**Request for Additional Information No. 56, Supplement 8**

**U. S. EPR Standard Design Certification**

**SRP Section: 07.09 - Data Communication Systems**

**Question 07.09-2:**

Figure 7.1-3—Safety Information and Control System Architecture (Safety-Related Port

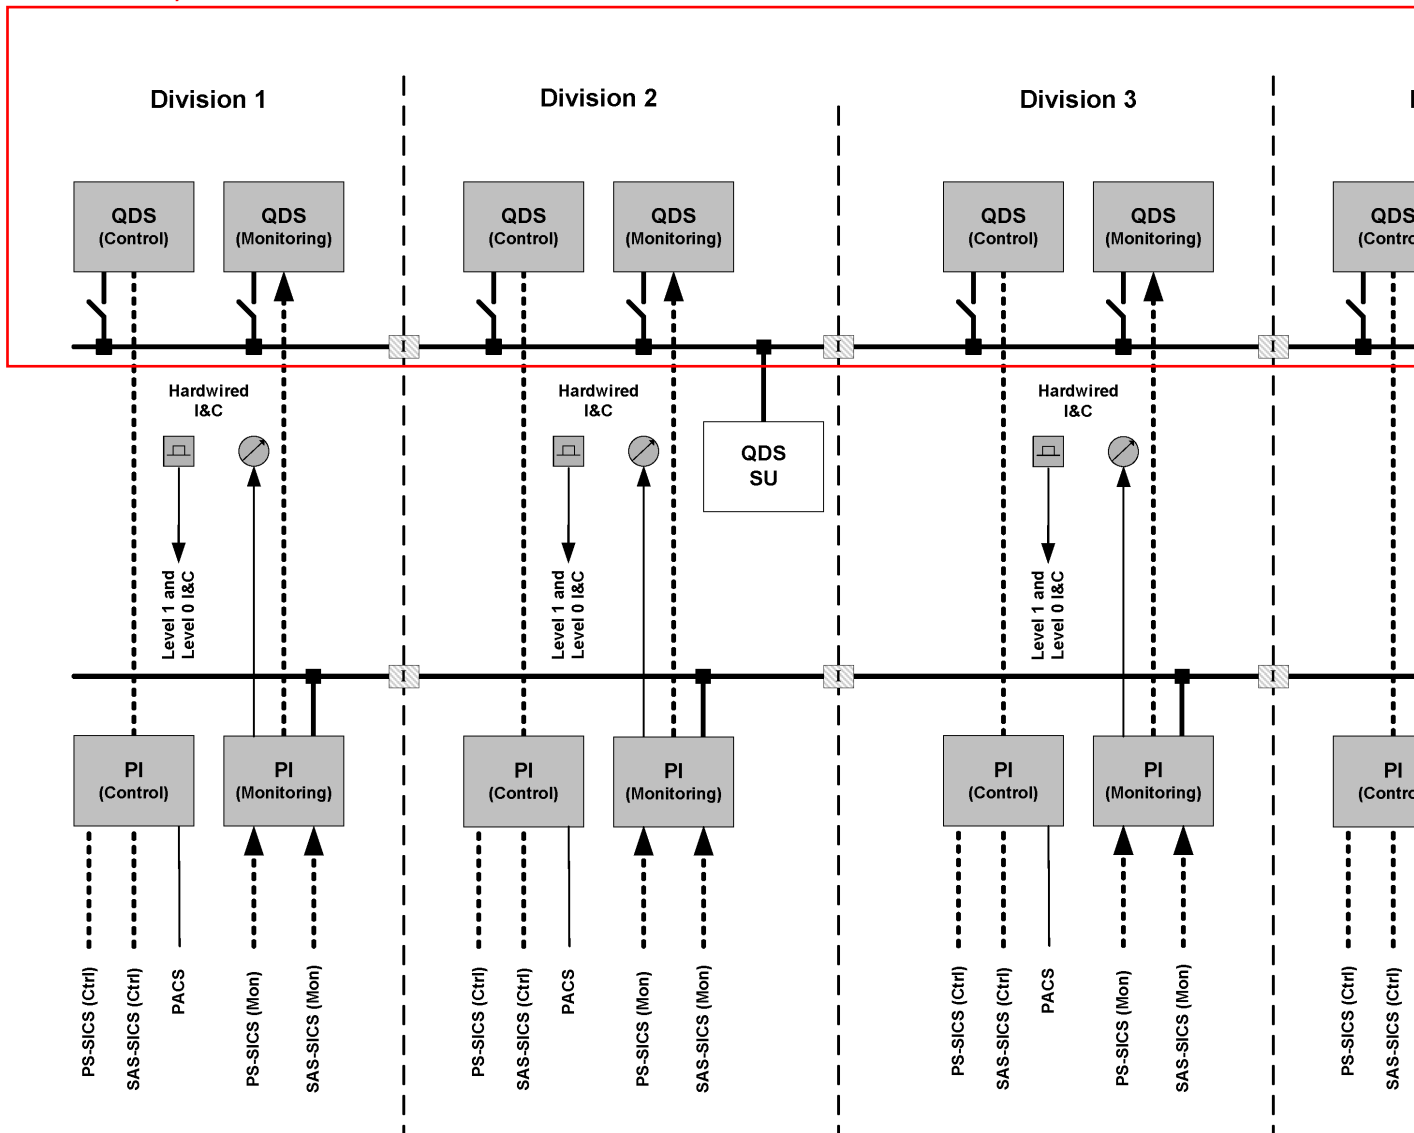
Clarify the classification of safety components within the SICS. In addition, how is independence achieved between safety portions and non-safety portions of the SICS to meet IEEE Std. 603-1991, Clause 5.6.3, and 10 CFR Part 50, Appendix A, General Design Criteria (GDC) 24?

Demonstrate how the interface between the qualified display system (QDS) and the non-safety service unit (SU) satisfies IEEE Std. 603-1991, Clauses 5.6.3 and 5.9 requirements.

The safety information and control system (SICS) is classified as a safety-related system, but it contains independent safety-related and non-safety-related portions (see U.S. EPR FSAR Tier 2, Figure 7.1-2).

In place of a MSI, communication independence is achieved by disconnecting the SUs from the QDS computers when the QDS computers are inservice and performing their safety-related functions.

Although the non-safety-related QDS SUs load QDS software and off-line troubleshoot, the QDS computers are not normally connected to the SUs. The SU is only connected to the QDS when the QDS is out of service. A key lock switch maintains disconnection between the QDS and the SUs during normal operation and is controlled administratively. The switches include a device that provides electrical isolation between the QDS and the SU, and the switches interrupt the communication channel between the QDS and the SU, consistent with ISG-4. U.S. EPR FSAR Tier 1, Section 2.4.2, Item 4.13, U.S. EPR FSAR Tier 2, Section 7.1.1.3.1, Figure 7.1-3, and Figure 7.1-21 will be revised to include a switch between the QDS and the SU. The revised ITAAC will demonstrate how communication independence is maintained by keeping the devices disconnected.

U.S. EPR FSAR Tier 2, Section 7.1.1.3.1, Section 7.1.1.6.4, Figure 7.1-3, and Figure 7.1-21 will be revised as described in the response and indicated on the enclosed markup.

Figure 7.1-3—Safety Information and Control System Architecture (Safety-Related Portion) provides a functional representation of the safety-related portion of the SICS.

- **Service units (SU).**
